**DOCKET ITEM #10**  
**Development Special Use Permit #2025-10023**  
**Encroachment #2025-00008**  
**Potomac Yard Landbay G – Blocks B & E – Mixed-Use Residential**  
**2901 Main Line Boulevard & 2900 Potomac Avenue**

**Staff Recommendation: APPROVAL WITH CONDITIONS**

DSUP#2025-10023 | Mixed-Use Residential Building  
Potomac Yard Landbay G - Blocks B & E  
2901 Main Line Boulevard & 2900 Potomac Avenue

**Condition #11 Exhibit – Potomac Ave and E. Glebe Rd Elevations**

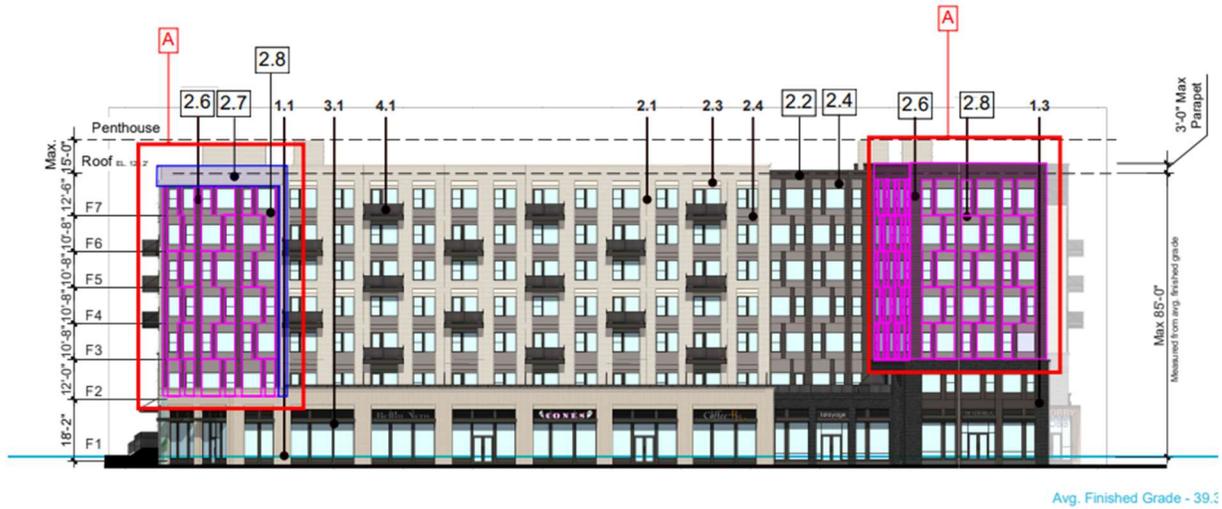
- b. The underside of all balconies facing the public ROW shall be finished and present a visually cohesive appearance.
  - c. The applicant shall revise the materials of all solid components on the “A” corner features identified in the attached Exhibit 1, dated November 21, 2025, from fiber cement to metal above the brick base.
